99-101 OLD BURLEIGH ROAD INFORMATION REQUEST RESPONSE

Cardno now Stantec (Stantec) has been engaged by Urbis to provide traffic engineering advice in relation to the proposed development on 99-101 Old Burleigh Road. As part of this development, Stantec prepared a traffic assessment (dated 10th of November, 2021) which was submitted to Council.

Following their review of the traffic assessment, Gold Coast City Council (Council) issued an Information Request (reference no. MCU/2021/603, dated 15 December 2021), which included comments regarding traffic and transport aspects of the development. Stantec provided a response to the IR on the 20th May 2022, to which Council have provided informal additional advice, in the form of an email received on the 1st July 2022, and a meeting undertaken on the 7th of July 2022. As such, Stantec have prepared the below response

Council Basement 1 proposed hold lines

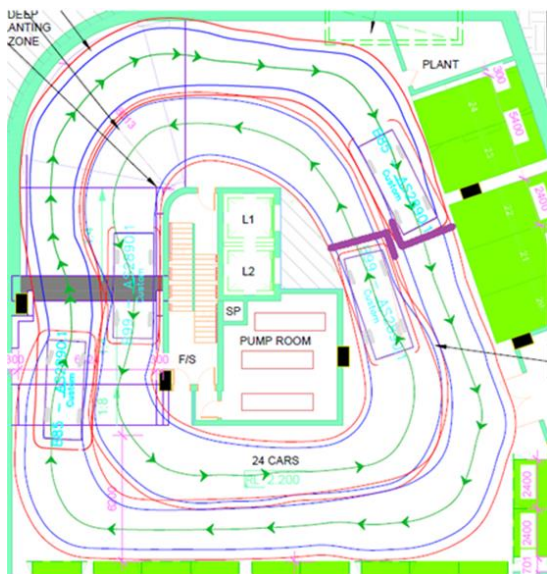
Basement levels still show 'pinch points' at various locations within the circulation paths, which may result in conflict between opposing vehicles. To manage circulation within basement levels, a 'warning' system shall be installed, consisting of flashing lights and hold lines (rather than full

signalisation of basement ramps). **Development drawings shall be updated to show all required equipment, hold lines etc.**

Note – hold lines shall be generally located as shown in purple, below in the eastern aisles of Basement levels B1 and B2 (management of circulation in B3 is not deemed necessary given the limited number of movements (relatively) and the fact that the eastern parking aisle is wider than in B1 and B2).

Stantec has reviewed the basement ramps, circulation roadways and parking aisles and found that these have been designed in accordance with Australian Standards AS2890.1.

Stantec's methodology was to identify the various areas of a car park as per AS2890.1 and apply this to the current car park arrangement. This is shown in Figures 1-1 & 1-2, where:

As shown above, there provision is more than required to meet AS compliance. As such, Council's proposed warning system will only impede traffic operations and is not required from an operational standpoint.

Figure 1-4 Ground Level MRV Loading Zone

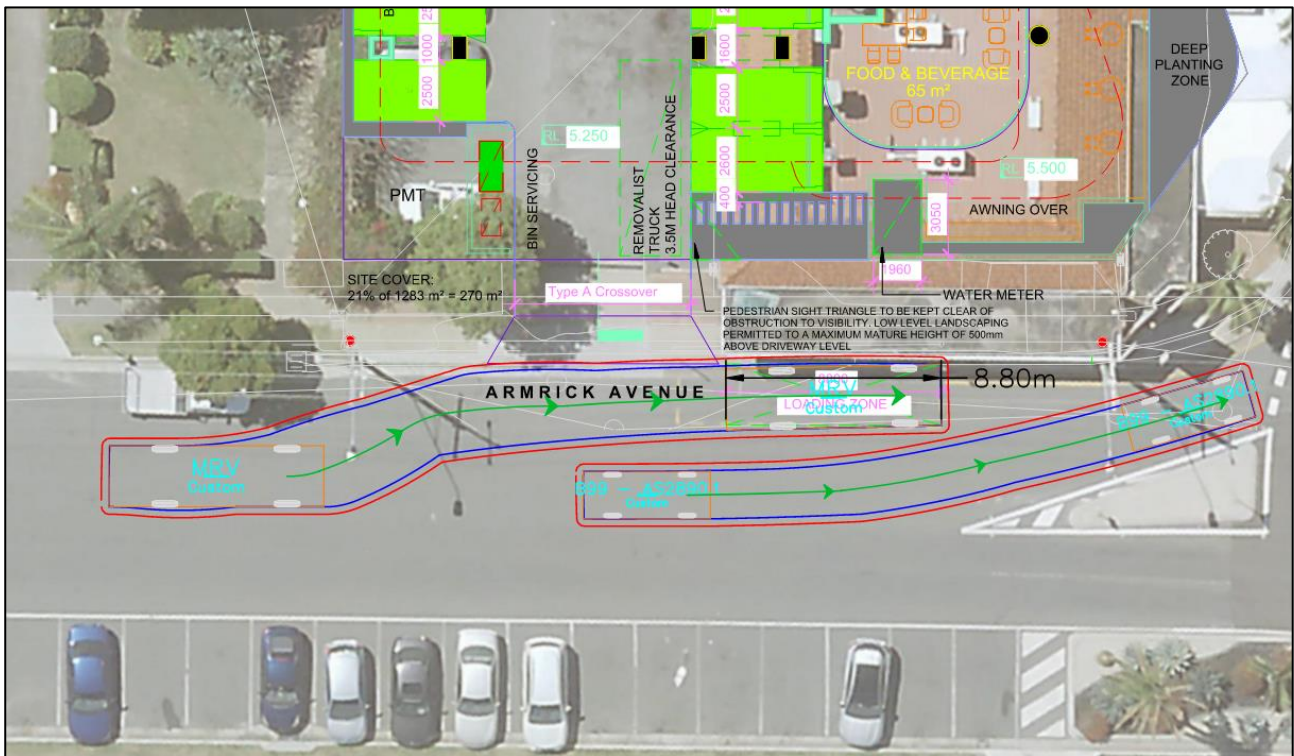
As identified in Council's Information Request, the proposed crossover on Armrick Avenue appears to conflict with the location of the existing on-street loading zone (would reduce the length of the loading zone)

The applicant was requested to demonstrate (through drawings) any impacts to the loading zone (i.e. show the loading zone on development drawings to identify its position relative to the proposed crossover, and provide a fully dimensioned concept plan showing any proposed modifications to the loading zone for consideration by council's Asset Custodian). This request has not been addressed.

Of note, this information is critical to considering the proposal for on-street servicing for the proposed Food and drink outlet – it is unclear whether the reduced length of the loading zone would be sufficient to accommodate a 6.4 m SRV; in addition, options for relocating the loading zone (to retain its length) appear to be limited given its proximity to the roundabout.

Servicing operations have been reviewed and are shown in **Appendix B**. The on-street servicing bay will be shorted to a minimum of 8.8m long, which is compliant for MRV servicing in accordance with AS2890. Additionally, the loading bay is also suitable for servicing via a SRV service vehicle (6.4m required length). Whilst the width of the bay is acknowledged to 2.5m wide this is a suitable width given the:

- > sufficient width available for passing movements by local vehicles when servicing
- > adjacent footpath area available for servicing of goods to/from the vehicle
- > historic layout of the servicing bay

A swept path showing the suitable usage of the loading zone by an MRV and the length of the MRV bay is shown below in Figure 1-4.

Urbis 99-101 Old Burleigh Road, Broadbeach Ramp Swept Paths Level 1			
Drawn R Bakon	Date 17/07/2022	Scale 1:200	Size A3
Drawing Number T0921032 - SK04			Revision H

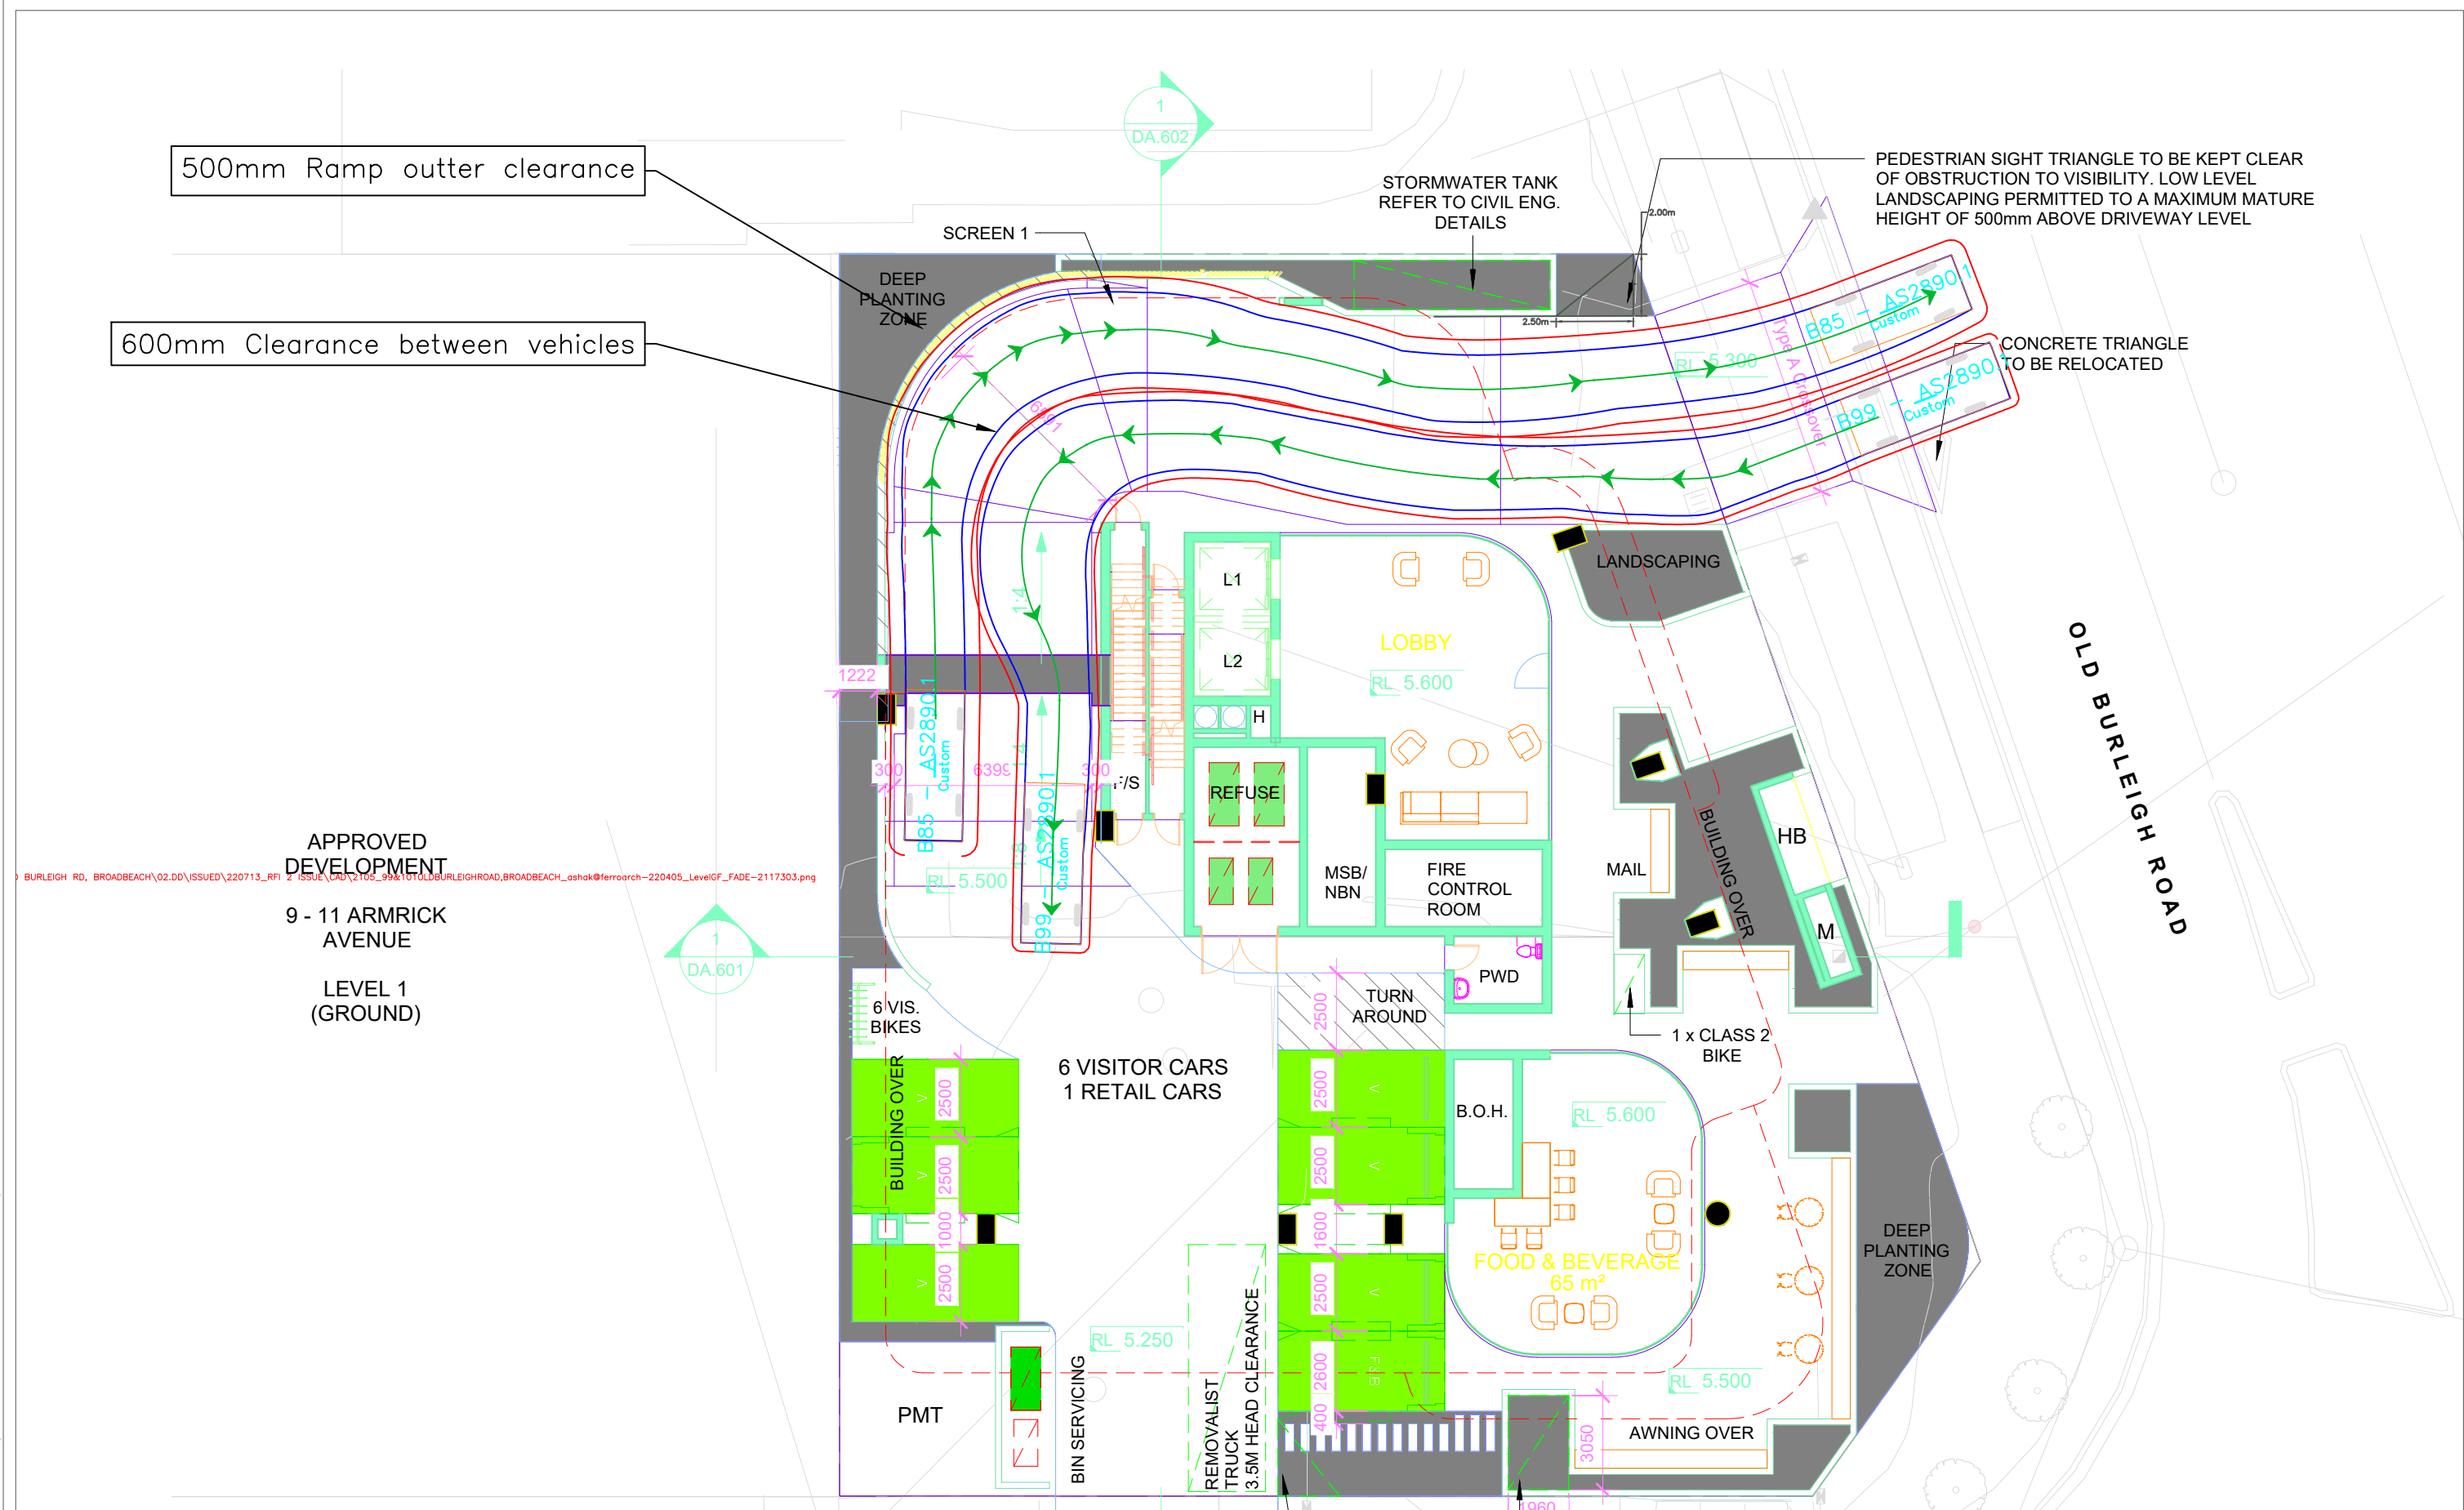
Podium level 1 still includes a single-lane, two-way aisle (eastern aisle is only 5.3 m wide, at its narrowest point); swept paths show conflict between opposing vehicles at this location, and management of vehicle movements has not been proposed;

Management of vehicle circulation is required in podium level 1 (method of management for vehicle circulation to be determined based on vehicle circulation as a result of changes to setbacks i.e. Single lane or two way circulation, this may require full signalisation rather than a warning system). A Traffic Engineering review shall be undertaken to identify an appropriate passing location for opposing vehicles in podium level 1. The passing location (hold lines) shall be supported by swept paths demonstrating the ability for two vehicles to pass (while maintaining compliant circulation clearances – this includes 600 mm clearance being maintained between passing cars). **Development drawings shall be updated to show all required equipment, hold lines, etc**

Alternatively, the applicant shall submit amended drawings demonstrating revised geometry in podium level 1 to remove the single-lane section of aisle (management of circulation in podium level 2 is not deemed necessary given the limited number of movements (relatively) and the fact that podium level 2 does not include single-lane aisles).

Stantec have outlined the required hold lines for a one-way ramping system. Hold lines and swept paths outlining the one-way movements have been included in **Appendix B**. The exact positioning of the stop lights will be resolved as part of detailed design.

Providing the one-way arrangement for Level 1 including removing two (2) small car bays from the layout and replacing them on Basement 2. Swept paths have been included showing suitable vehicle ingress & egress from these revised parking spaces, and is included in **Appendix B**. Note this results in no overall change to the parking provision.
